**2026 Glenwood Tank Site Projects:
Site Improvements (Secant Wall Installation)**

ADDENDUM NO. 2

The following clarifications and revisions are hereby incorporated in the Contract Documents, Construction Specifications and Plans for the project entitled, *"Glenwood Tank Site Project – Site Improvements (Secant Wall Installation), Scotts Valley Water District"*:

EXISTING SITE AND DEMOLITION PLAN

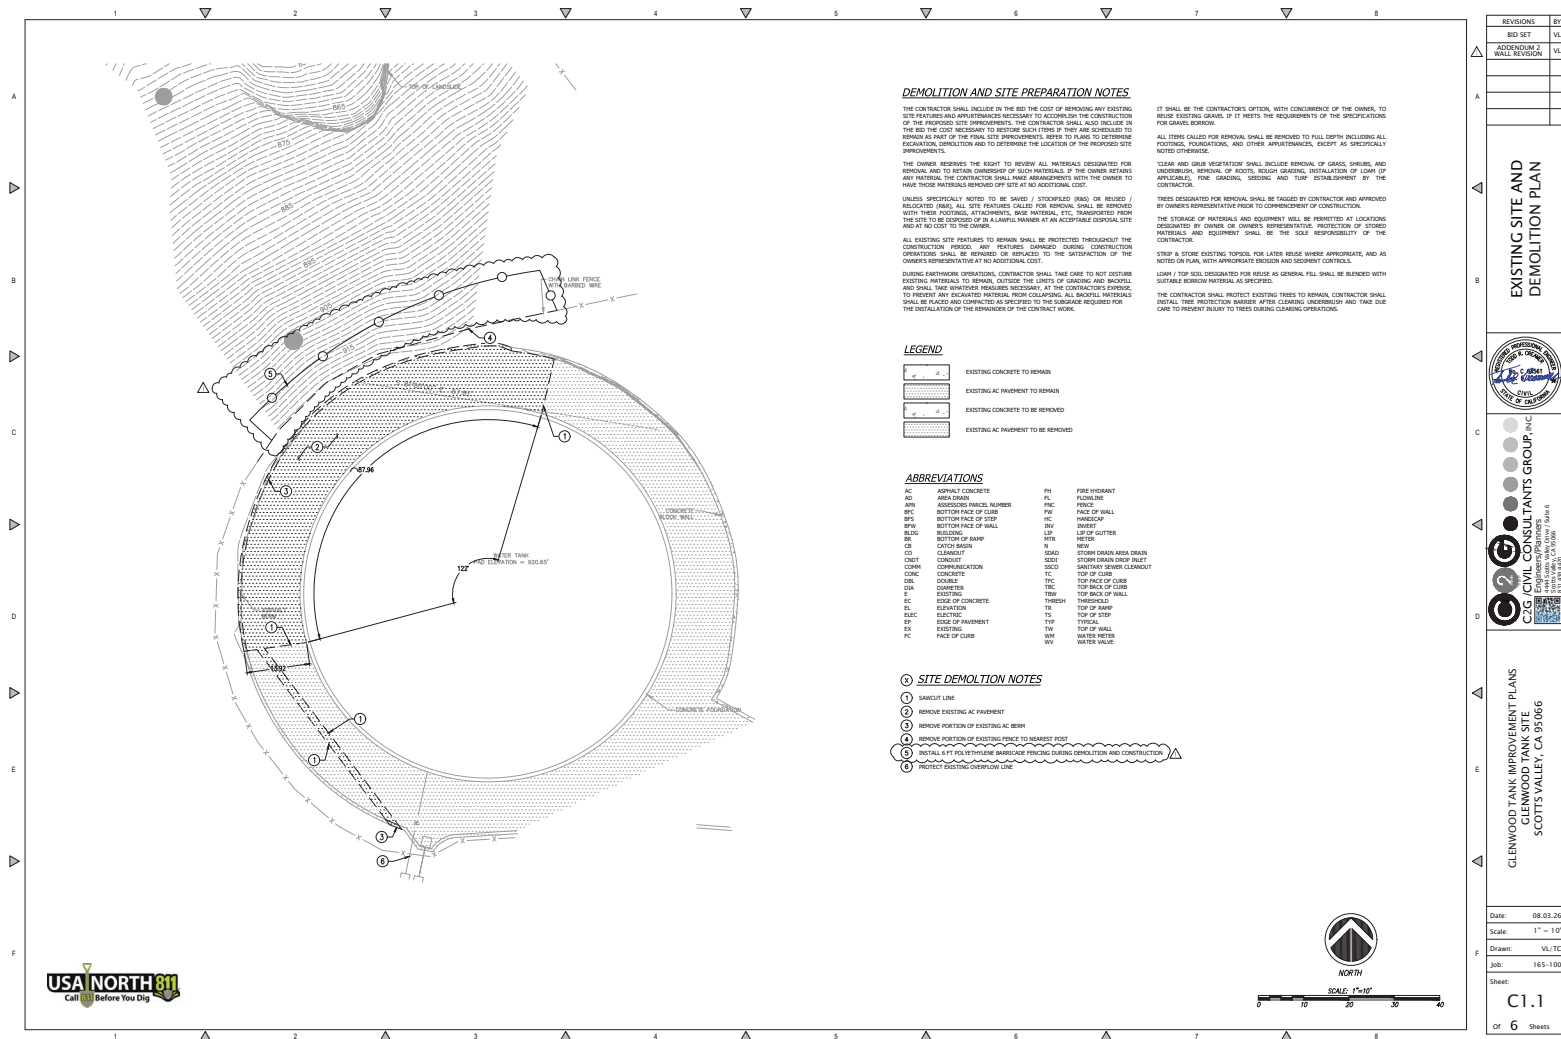
Sheet C1.1 - Existing Site Plan & Demolition,

Revision: Delta 1 – Addendum No. 2 – Secant Wall Revision

Add: Barricade fence location and height

Original 4-foot fence is not high enough for site protection for the District. Protective fencing can be incorporated with new bench and gabion basket.

1 TIE BACK RETAINING WALL PLAN
SCALE: 1"=1'-0"

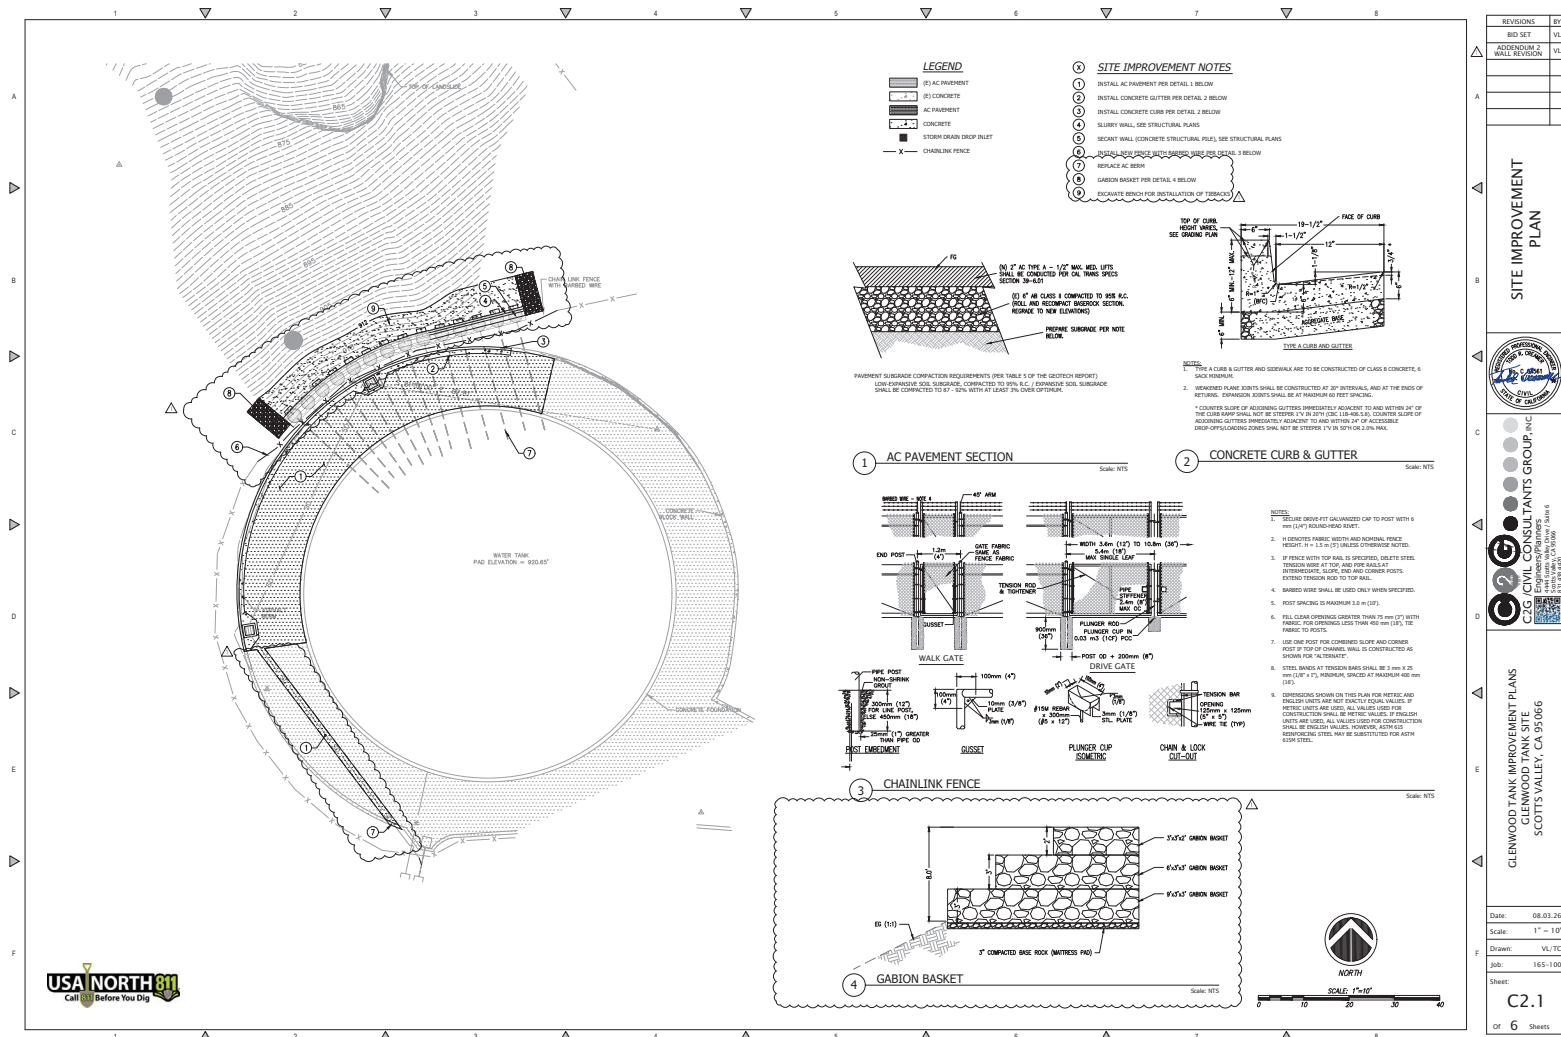
Sheet S1.0 - Foundation Plan,

Delete: Entire Sheet

Substitute: Revised Sheet S1.0 – Addendum 2 – Wall Revisions, dated 08-03-2026
